JLH Mark2 - An Improved Opto-Mechanical Approach to Open-Path *in situ* Water Vapor Measurement in the Upper Troposphere / Lower Stratosphere

This document contains our author final responses to both reviewers, first the responses to RC1 and second the responses to RC2.

We would like to thank reviewer RC1, Prof. Darin Toohey, for his excellent and detailed comments on our manuscript. Below are our responses to each comment in order.

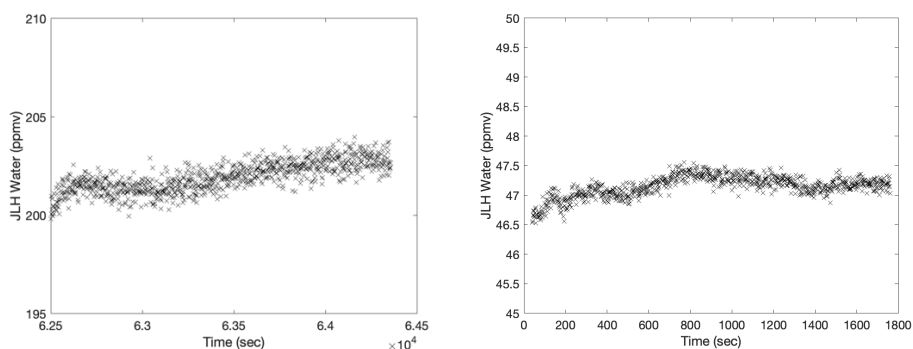
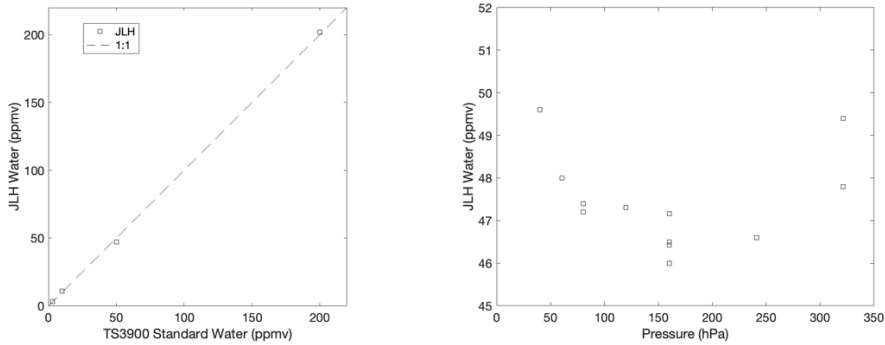
7. Line 577-588: The AIDA chamber demonstrations are an important “necessary” condition for the water vapor sensors that participated, meaning that one would expect the instruments to agree to within their stated uncertainties. In this case, you report “within 10% over a wide range of temperatures” which seems to be considerably larger than a back-of-envelope estimate of errors you note of 1% to 2% of various components of your careful analysis when added in quadrature. Because the JLH family of instruments are so critical to our understanding of stratospheric water, representing the only near-continuous record of in situ observations from aircraft spanning over three decades, it seems to me this paper is an excellent opportunity to “plant the flag” and make definitive statements about your best estimate for true uncertainty in the measurements without worrying about other methods which are much more difficult to “prove” from first principles. Although not required for this paper to be publishable, I think you

should expand on this section, if only a little, – perhaps ½ to 1 page – to provide your best “sense” of what the true uncertainties in the water vapor mixing ratios are when the instrument is working properly. Hopefully at some point you will have a more rigorous analysis of uncertainties, as this would be a very useful addition to the literature and historical record for JLH. Until then, would it be possible to make a summary statement about the largest sources of error in the JLH measurements and what they add up to in terms of accuracy over a typical range of pressures and temperatures for your flights?

In Section 2.3.2 (see below), we will provide a summary statement about the largest sources of error in the JLH measurements and what they add up to in terms of accuracy over a typical range of pressures and temperatures for recent flights. We will also revise Section 2.3.2 (at line 326) to show recent calibration results:

“Below, we describe a recent example of JLH laboratory calibration. Fig. 4a and 4b show time series of JLH measurements within the lab calibration chamber as 200 ppmv and 50 ppmv, respectively, are flowed through the chamber.

Fig. 4c demonstrates the linearity of JLH response versus reference gas standard from the TS3900 from 3 ppmv to 200 ppmv. This is also shown in Table 3 along with the difference in percent and ppmv. Generally, results are within 9% but there is a pressure dependence as shown in Fig. 4d. This pressure dependence has been documented in our previous

laboratory calibrations. At higher and lower pressures, the response changes systematically.

The best estimate of JLH total error for NASA SEAC⁴RS and more recent FTB flights is 12%, adding in quadrature the following terms. The largest error source is 9% in water measurement due to mismatch of the actual lineshape and the predicted lineshape as manifested as pressure-dependence (Fig. 4d). We estimate 5% uncertainty in water

measurement from uncertainty in the temperature dependence of the actual lineshape and 6% from scaling to laboratory calibrations (Fig. 4c and Table 3). There is 1% error in water measurement due to uncertainty in the in-flight temperature and pressure measurements. Finally, only 0.1% uncertainty in water measurement is due to uncertainty in the pathlength, and a fraction of a percent from other error sources such as wavelength, laser spectral purity, light scattering, et cetera.
